Release 1: This document supersedes previous revisions.
 Nov 10, 2014 Added desired bulb position and MUX software verification.

BITZER COMPRESSOR REMOTE PRESSURE SENSORS AND SWITCH

Prevost vehicles

Figure 4

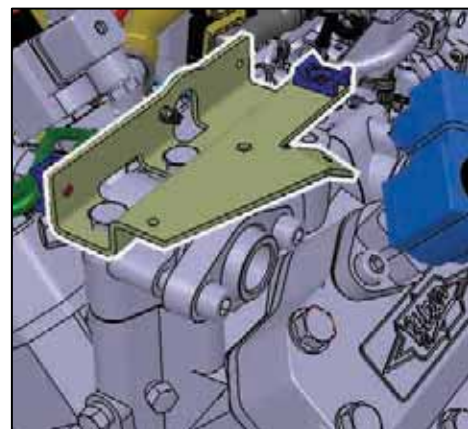
Perform this step if your vehicle has the latest version of the cable management bracket (Fig. 4).

Figure 5 Connector C228

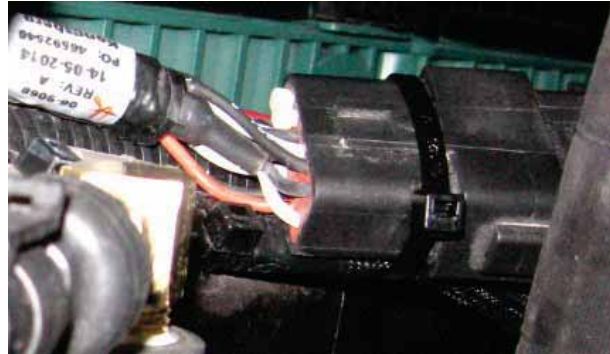
Look on cable management bracket located on the right hand side of the engine. (Fig 5)

On vehicle side, take the main branch leading to the old compressor pigtail. Remove loom, tape above the pigtail junction. (Fig. 6)

Figure 7 Connector cavity reference

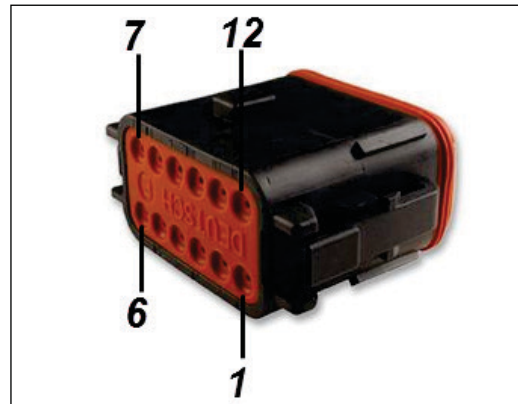
On Deutsch connector #563227 (C228), assemble the stripped wires with terminals and insert them in the indicated positions per wire circuit (see table below).

Figure 8

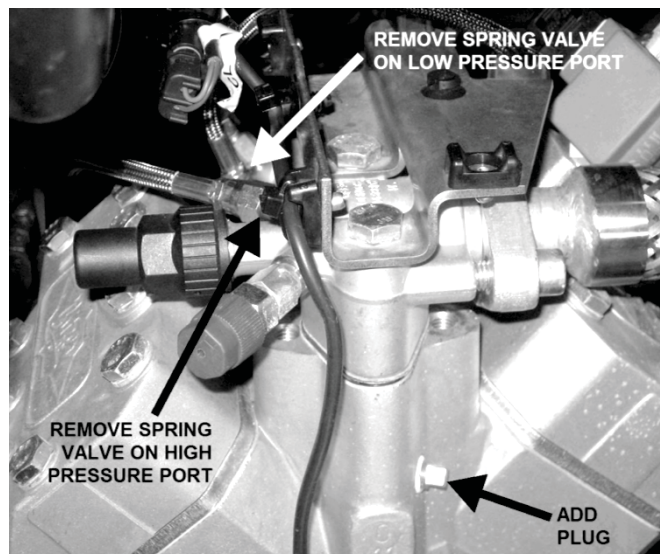
Install plug #501303 in port where SE23 was installed. Seal with #680869. (Fig. 8)

At location where was installed SE29, remove Schrader spring valve inserted in fitting. (Fig. 8)

Figure 9 : SE23 & SE29 Assembly

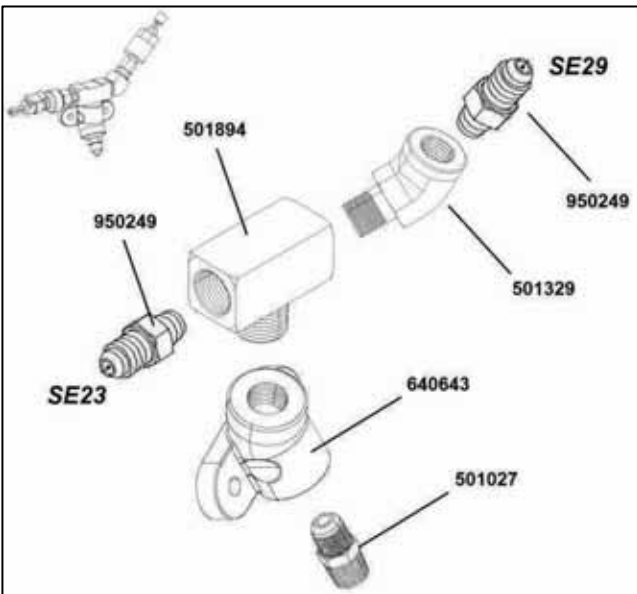
Assemble one each of these two assemblies, adding the transducers and switch at indicated locations. (Fig. 9 & 10)

Figure 12

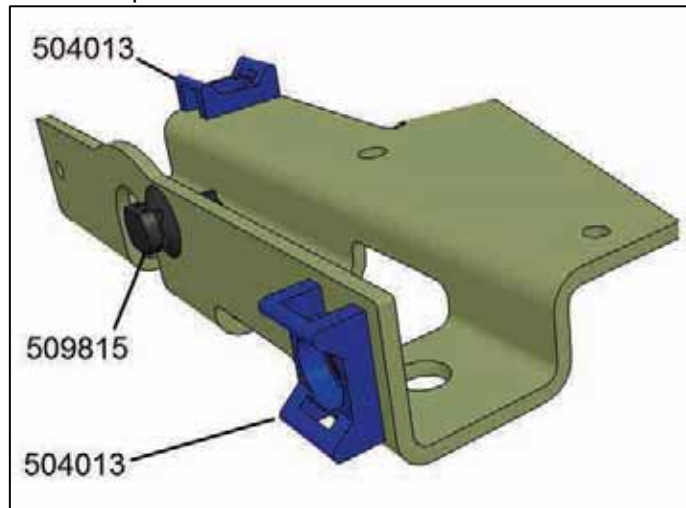
Place cable tie bases #504013 with Stainless Steel dome pop rivets #504379. (Fig. 12)

Add one #509815 cable tie base with christmas tree in the hole located in the center of the cable support.

Figure 13

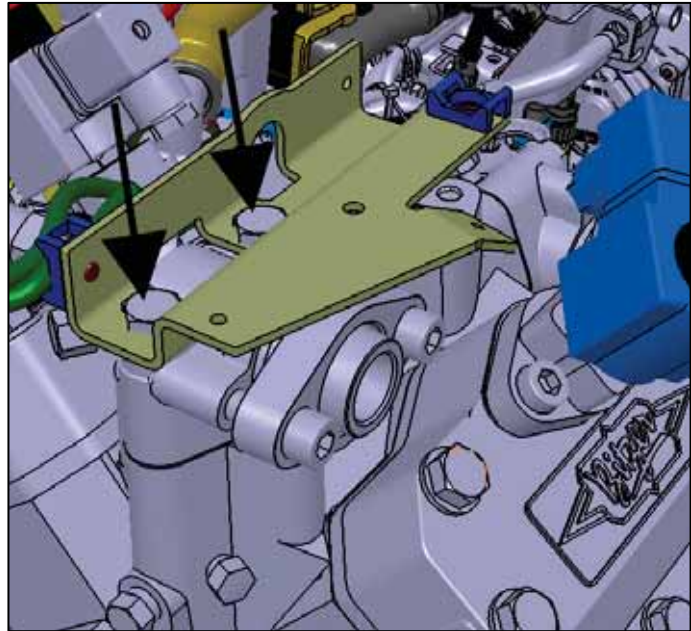
Install new support #067349 as shown.
Torque discharge valve cover bolts to:

38-42 lbf -ft.

Figure 16: Drilling on the cable support

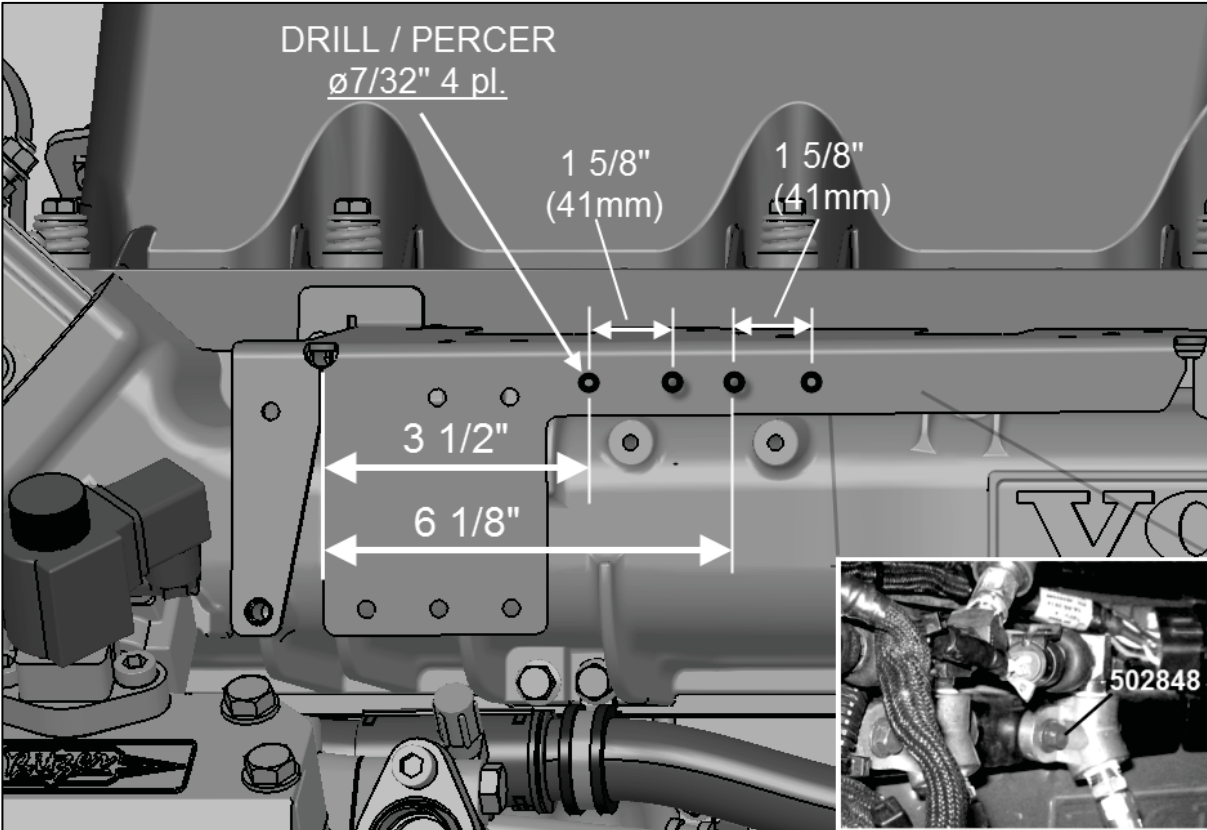
- 2.10. On certain vehicles the cable support will not have reference holes.
Four (4) new holes will need to be drilled. Use dimensions provided below. (Fig. 16)

Secure fitting assemblies with thread cutting screws 502848 (Fig 16)

Figure 17 Rear view

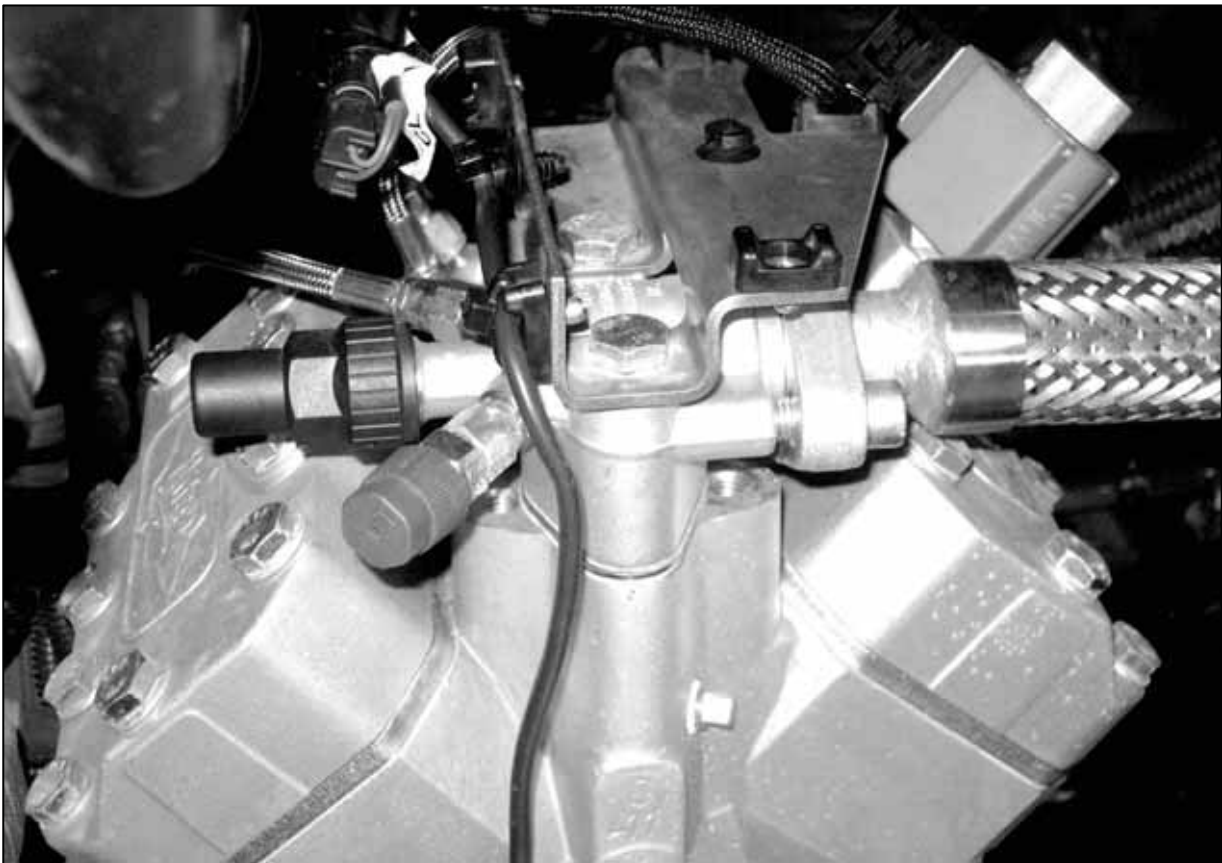
- 2.11.1. Install new harness **069206** by connecting **L199** to the unloader.
- 2.11.2. Secure the cable on the cable tie mounts. **Until 069099 is available as a service part, route to avoid sharp edges.** (Fig. 17, 18).
- 2.11.3. Connect **So9** to the clutch connector.
- 2.11.4. Install one swivel cable tie base **504751** on the flexible section of the oil fill tube. (Fig. 18). Secure clutch connector in an orientation that allows easy disconnection. Tie excess length of cable by making loops. (Fig. 18)

Figure 24 Harness routing to remote instruments on engine.

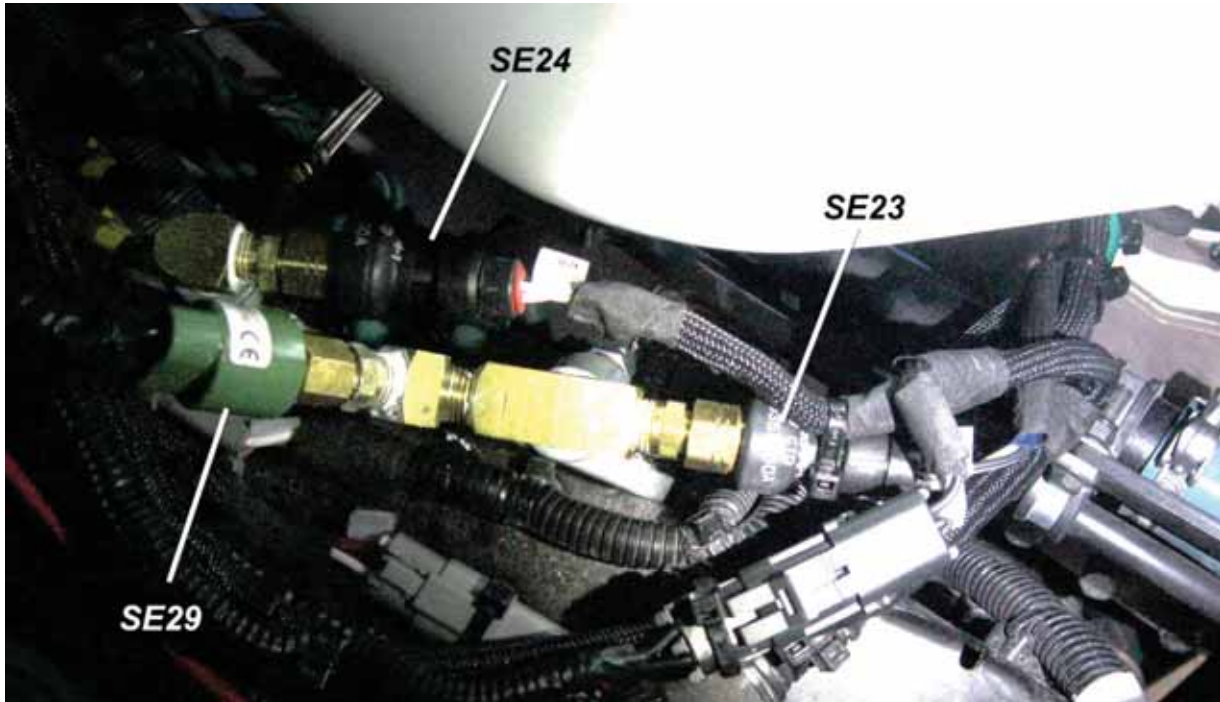
Route harness towards engine and connect to the transducers and switch installed on the fitting assemblies. (Fig. 24) Secure with cable ties.

Figure 29

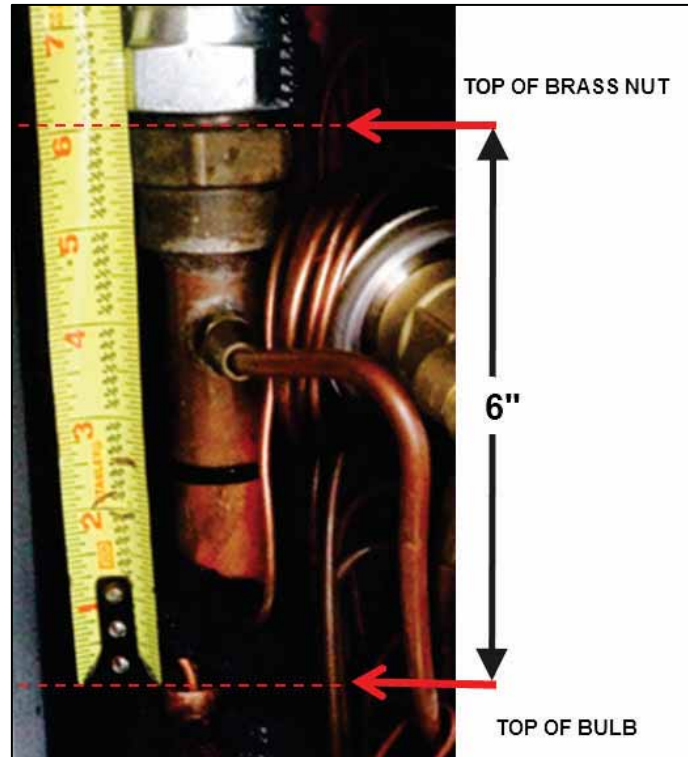
On the evaporator, inspect the expansion valve bulb position and adjust to 6" from top of brass nut, as indicated in fig 29.
